Dealer Service Bulletin

NO.: 7SB005-23-01A
SECTION: Plumbing
DATE: September 19, 2022

SUBJECT: Shower Surround Sealant

Figure 1

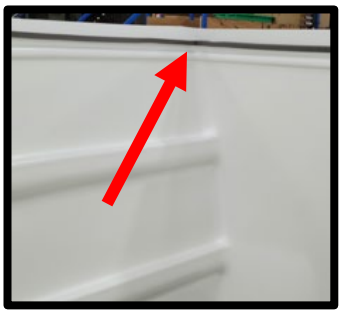
This bulletin is to advise you of a change to the shower surround sealant process. We have eliminated caulk-type sealant between the surround and the shower pan in favor of a closed-cell foam installed behind the shower surround. This will prevent moisture from getting behind the surround and eliminates the need for visible, caulk-type sealant.

Please be sure to pass this along to your staff so they are aware that the shower is not missing sealant. Reference photos below. Figures 1 and 2 indicate the new foam, Figure 3 shows the surround with no sealant.
